ROUNDEL HOMES INC. (PH-2)

LOT No. 44

PRAIRIE ROSE DRIVE

PART OF LOT 29,
CONCESSION 2
(GEOGRAPHIC TOWNSHIP OF MARKHAM, COUNTY OF YORK)
CITY OF RICHMOND HILL 65M-4737
REGIONAL MUNICIPALITY OF YORK

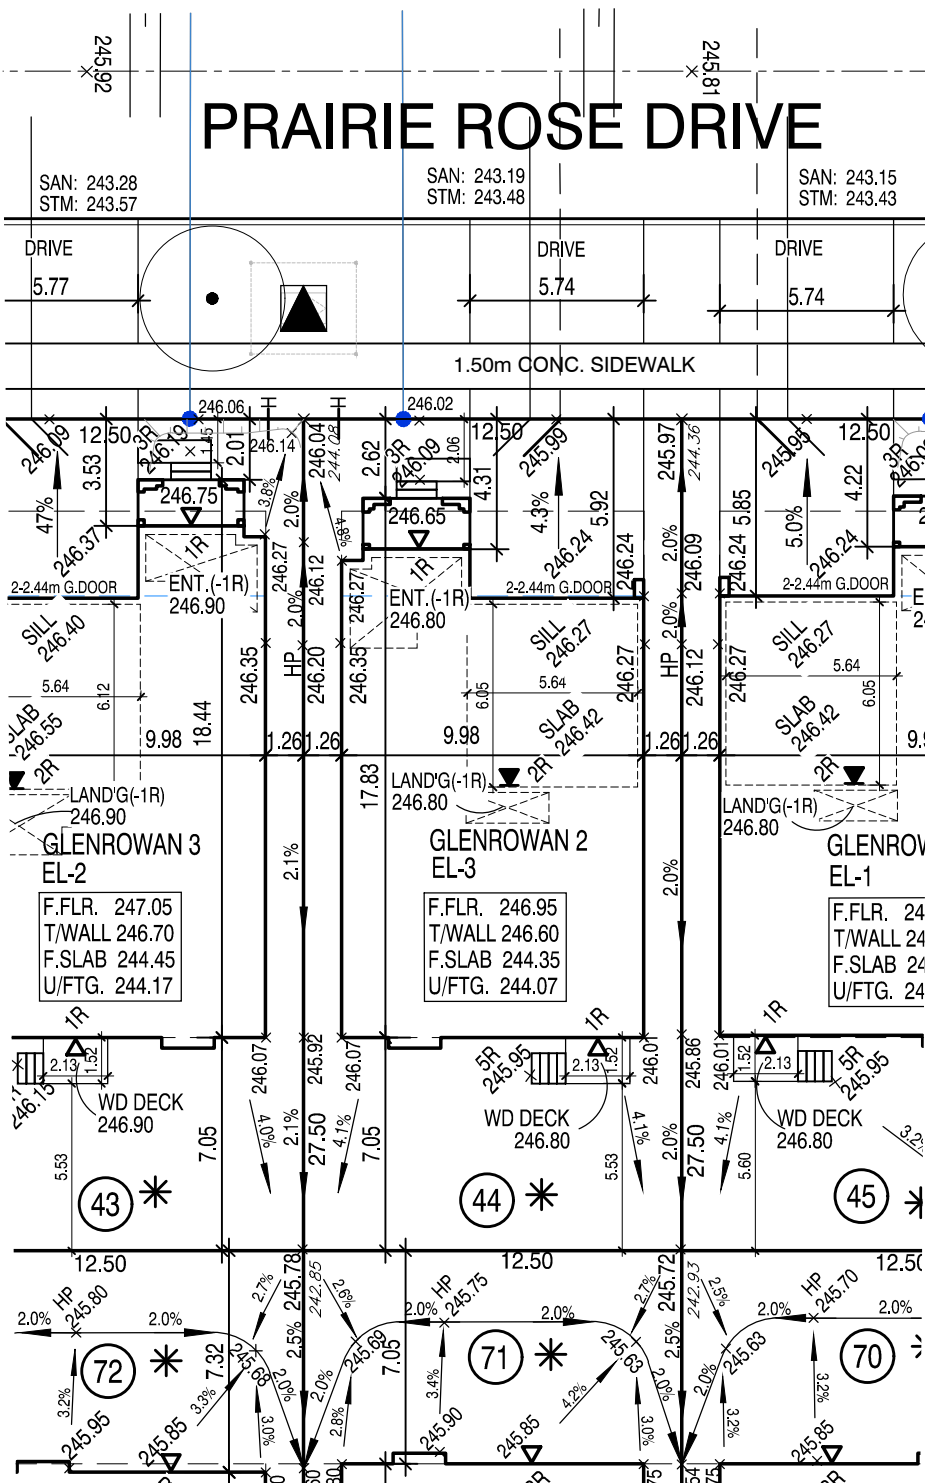
No unprotected openings permitted within 1.2 metres of the lot line as per 9.10.14 of the Ontario Building Code.

45 MINUTE RATED WALL
WITH SIDE YARD < 1.2m
